Council Assessment Panel Agenda & Reports

16 October 2023

Project
NEW RESIDENCE
For
STEVE & ALISON BROOKMAN
At
23 HARRIS ST, NORWOOD SA

White-pleated perforated metal screen

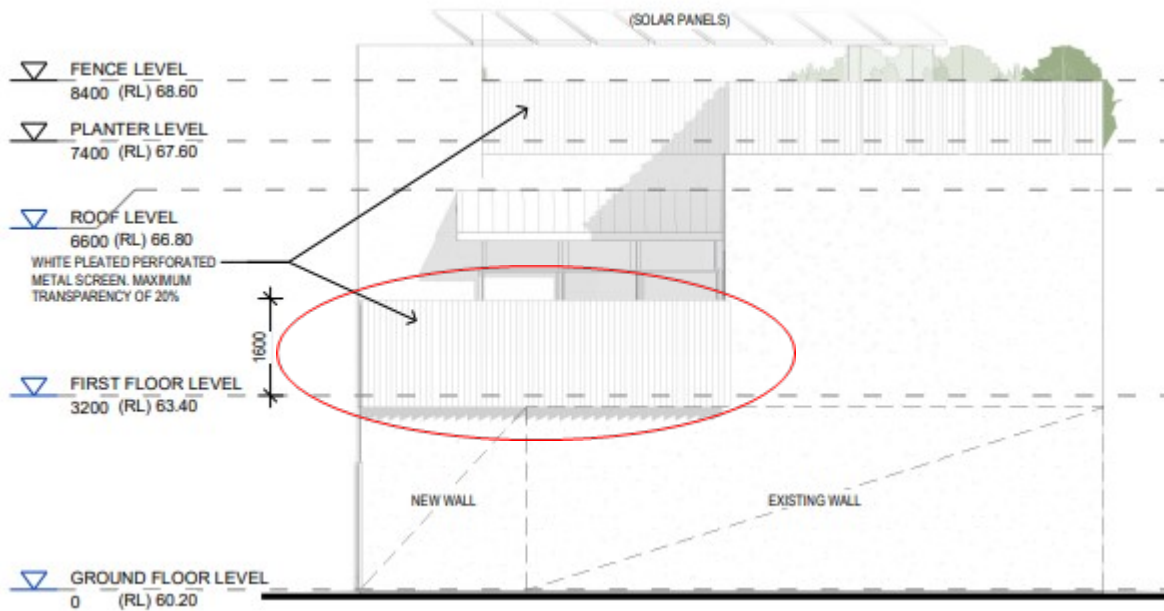
I share similar concerns about the eastern boundary wall as I do about the proposed screening along the eastern and northern boundaries of the site (below). I understand the intent of the screening is to prevent overlooking, but in my opinion it is unnecessary to place this screening on the boundary, atop 3.2m boundary walls. This only exacerbates the departures from the above Performance Outcomes, without any real justification. The screens ideally should be fixed to the exterior walls surrounding the windows they intend to screen; or alternatively the windows are treated with obscure glazing/privacy film.

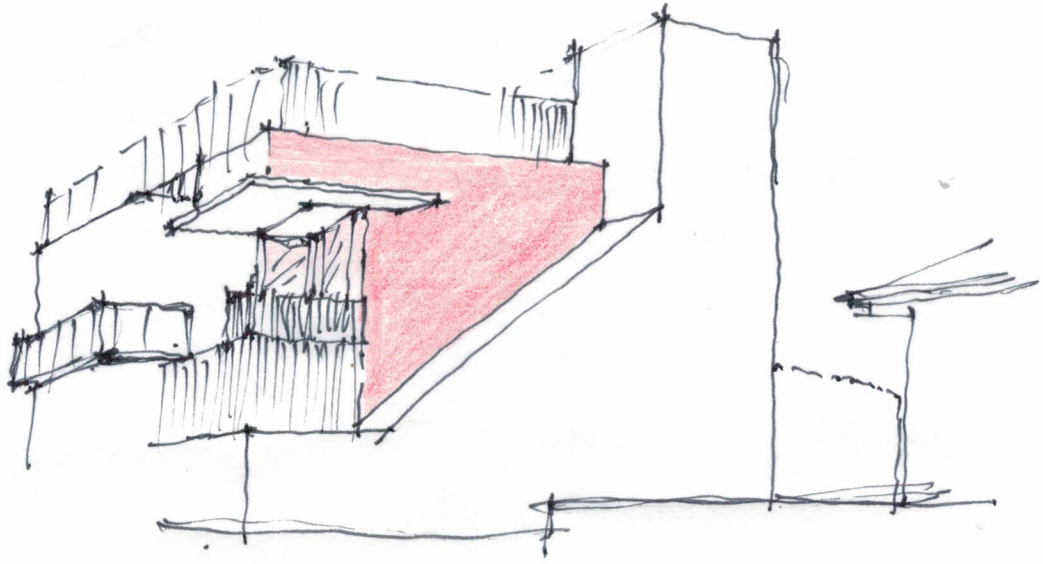
Looking mostly at the eastern wall of our building we think we can achieve pretty much what you are after. It is difficult to move everything off the boundary on the first floor even just where the stairs are. In part this is because there is not much room and also as the stairs need to come up somewhere. We cannot fit things well by taking the whole stair off the boundary.

We are thinking of making the roof line of the boundary wall follow the angle of the stairs, and then the main wall of that section can be set back from the boundary. While it may not be as much as 1.5m (not sure yet) it should be at least about 1m.
